SUBJECT: Forwards marked-up FSAR Pages 9A. 3-23 & Figures 9A. 3-4,  
 9A. 3-5 & 9A. 3-6. Change on Page 9A. 3-23 deletes ref to HPCS  
 room & 600-volt switchgear room. Changes will be incorporated  
 in future FSAR update.

Re: Nine Mile Point Unit 2  
Docket No. 50-410

## Nine Mile Point Unit 2 FSAR

FIGURE 9A.3-4

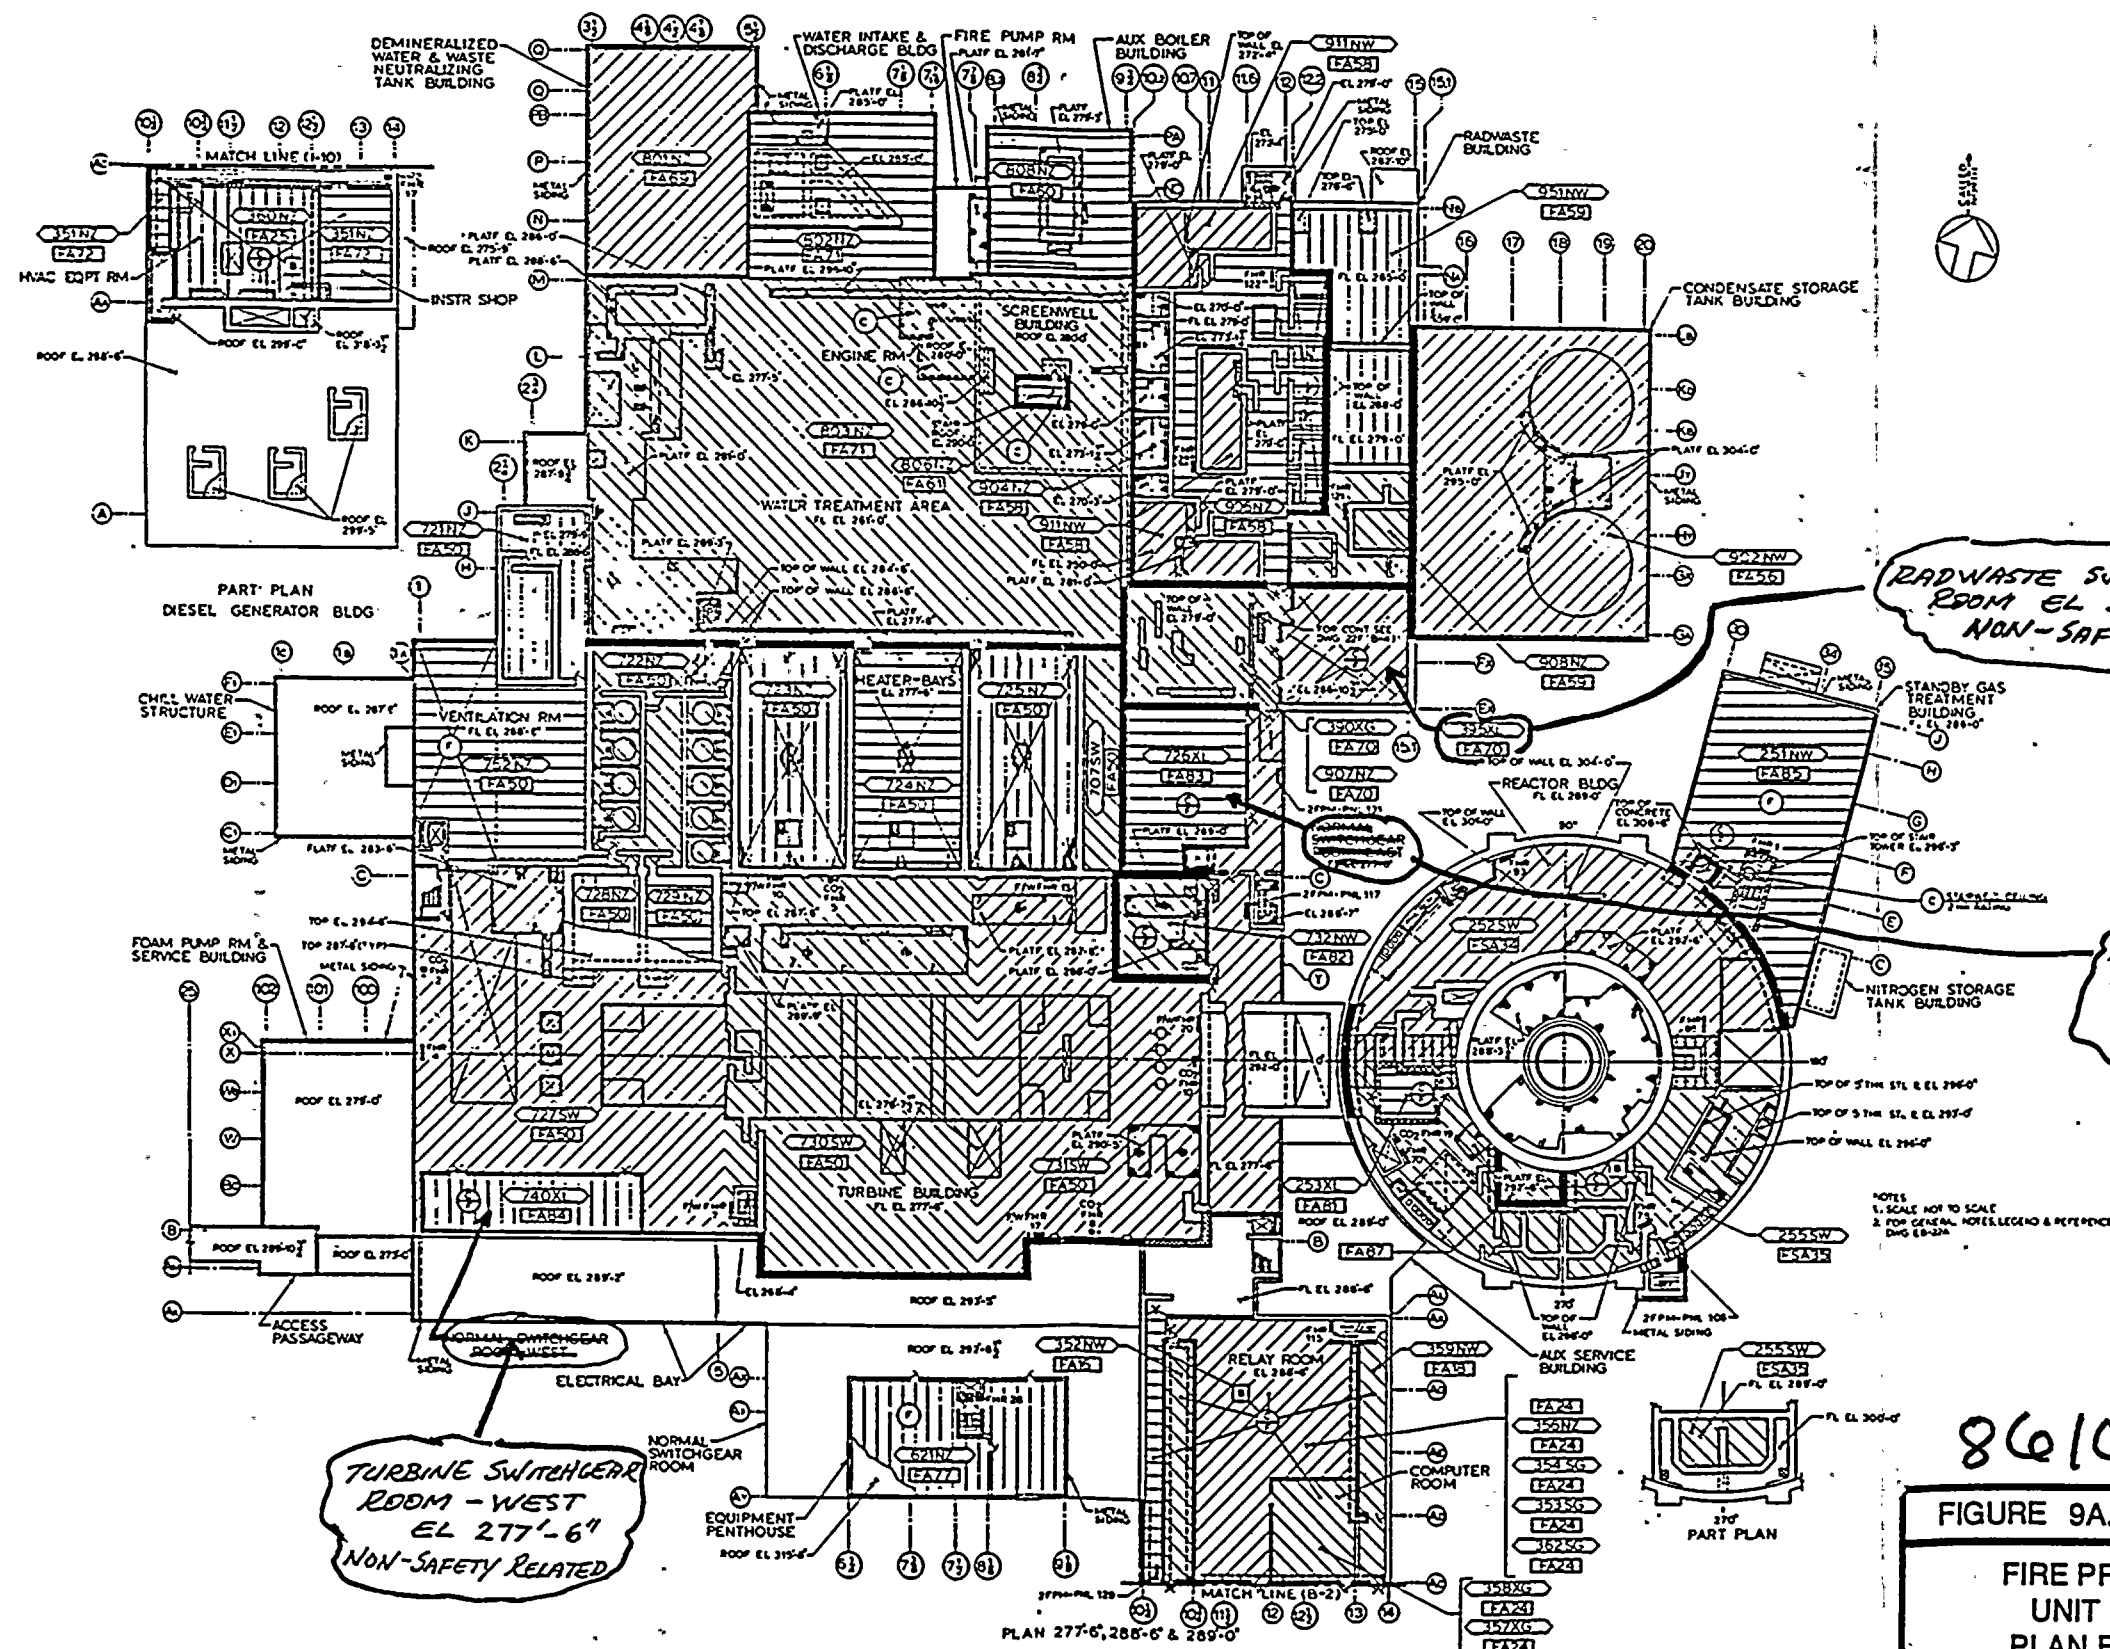
The changes on Figures 9A.3-4, 9A.3-5 and 9A.3-6 reflect our Safety Evaluation Report Supplement 4, Pages 9-12, 9-13 and 9-14, comments as discussed in recent letter NMP2L 0919, and as discussed with the Nuclear Regulatory Staff on October 21, 1986.

FIGURE 9A.3-5  
FIRE PROTECTION ARRANGEMENT  
UNIT NO.2 STATION BUILDINGS  
PLAN EL 250'-0", 261'-0" & 274'-0"  
NIAGARA MOHAWK POWER CORPORATION  
NINE MILE POINT-UNIT 2  
FINAL SAFETY ANALYSIS REPORT

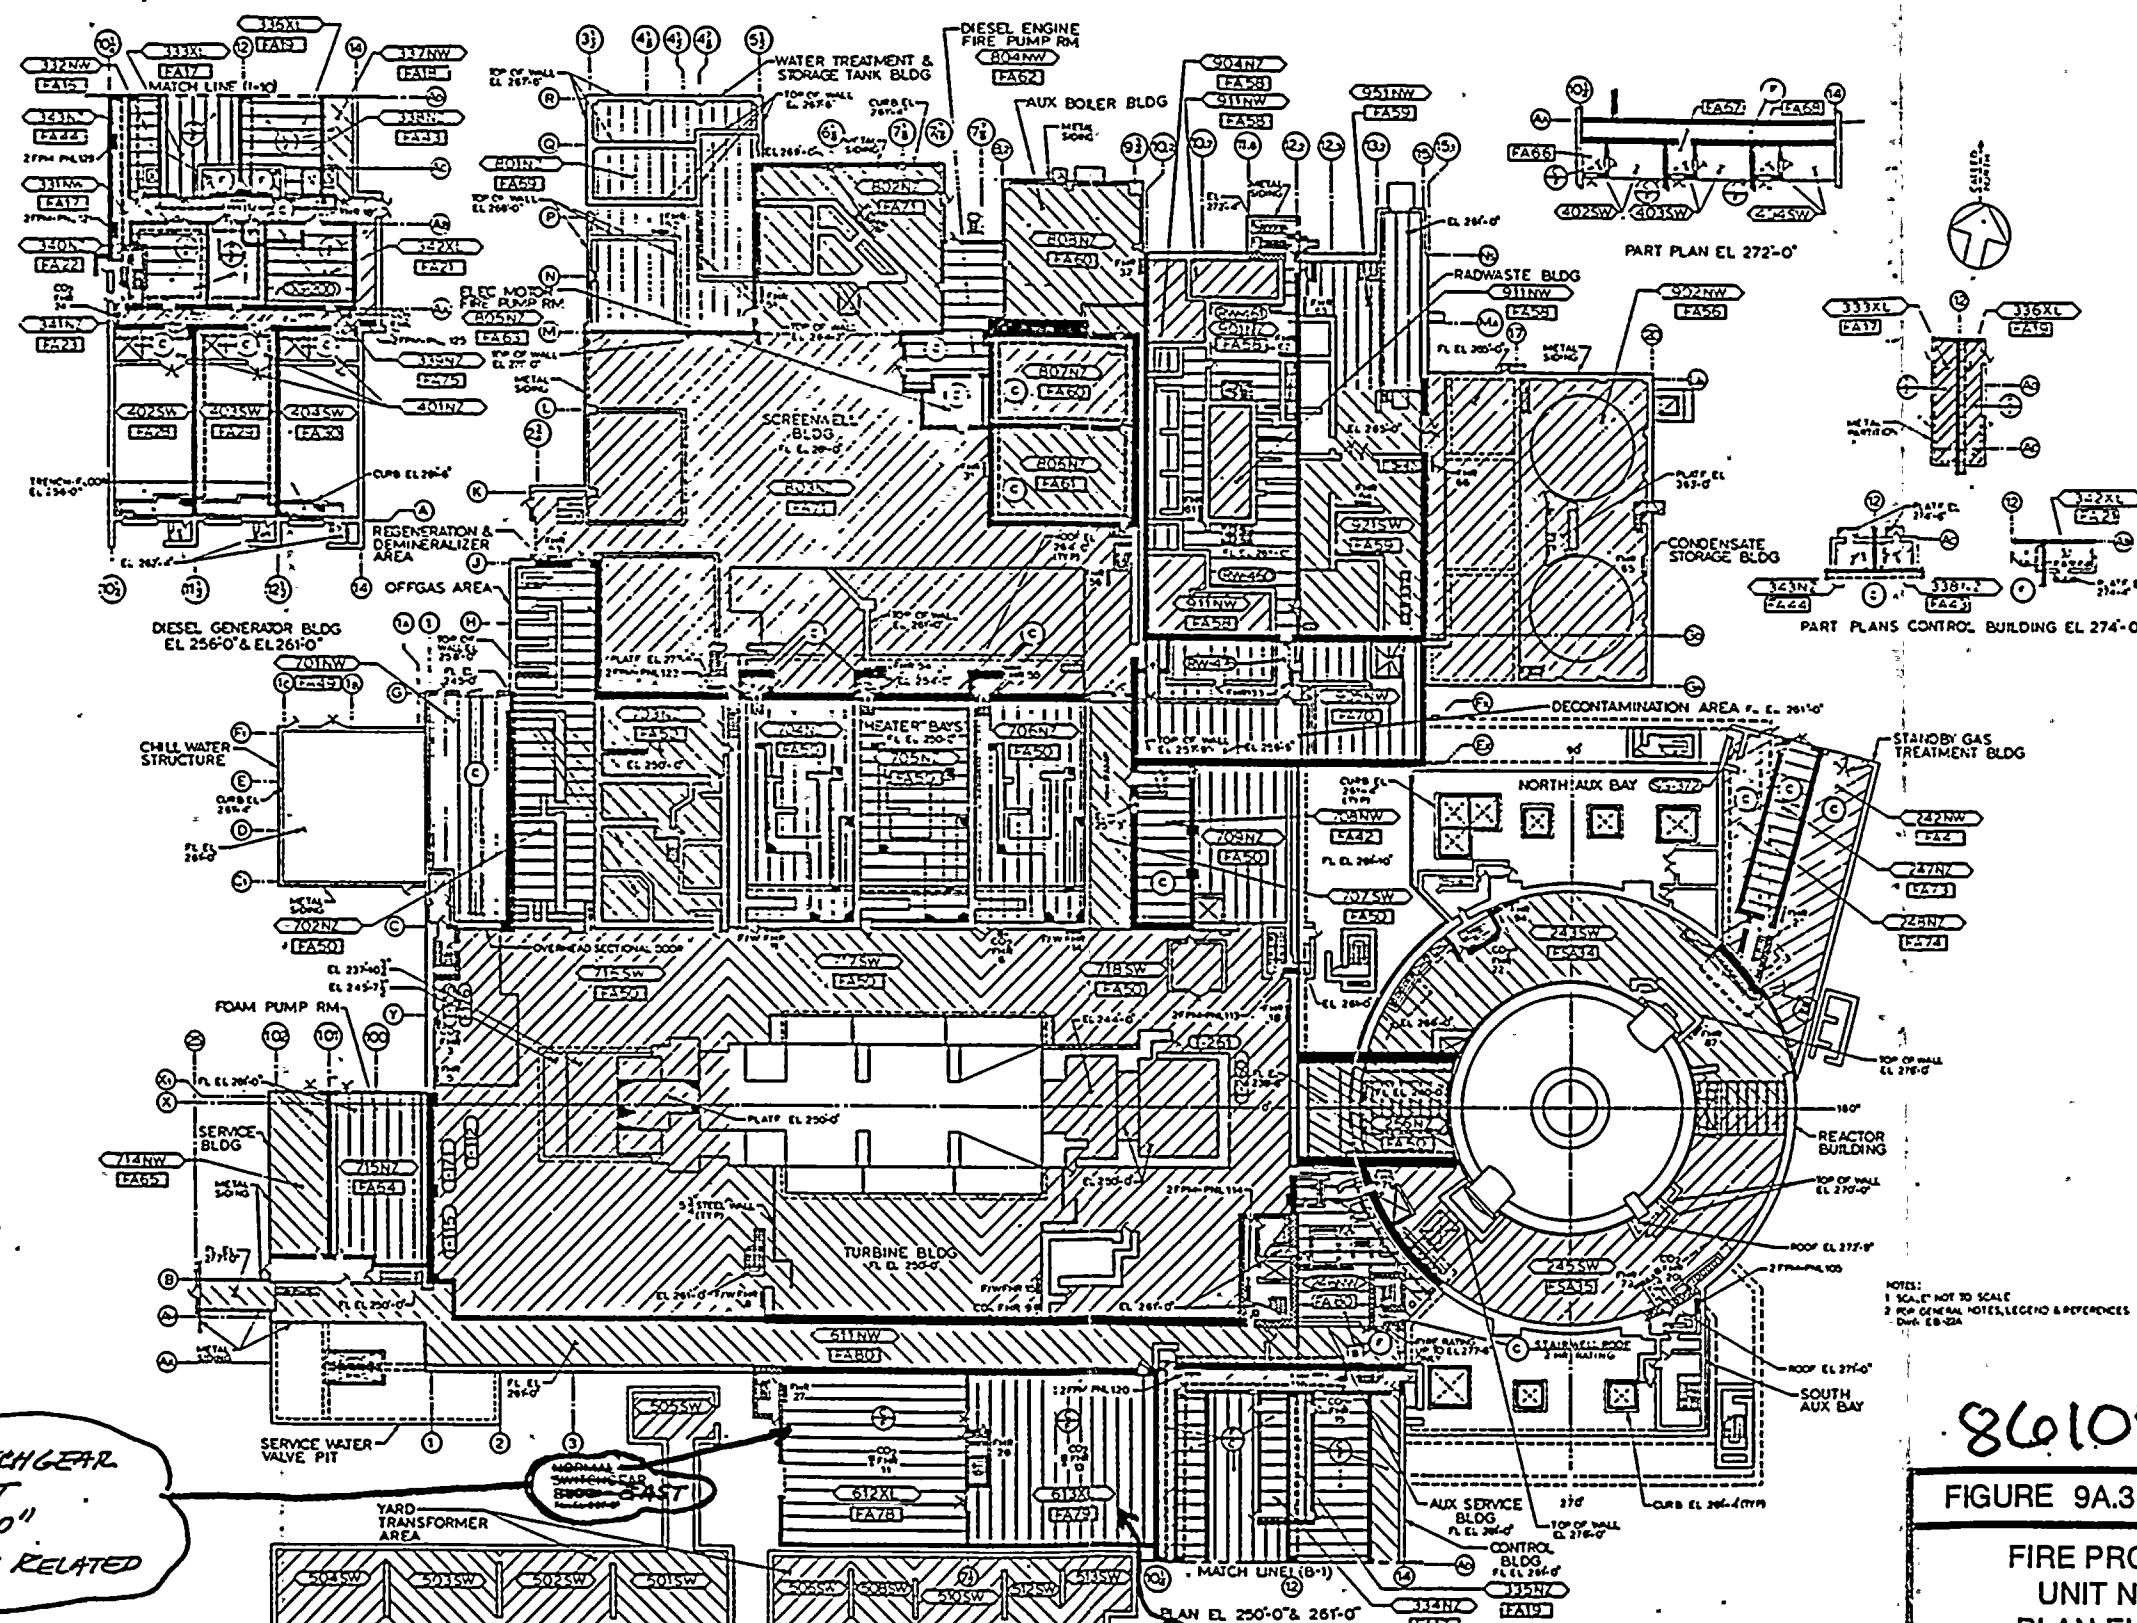
*NORMAL SWITCHGEAR  
ROOM - EAST  
FL EL 261'-0"  
NON-SAFETY RELATED*

*NORMAL SWITCHGEAR ROOM - WEST  
FL EL 261'-0"  
NON-SAFETY RELATED*
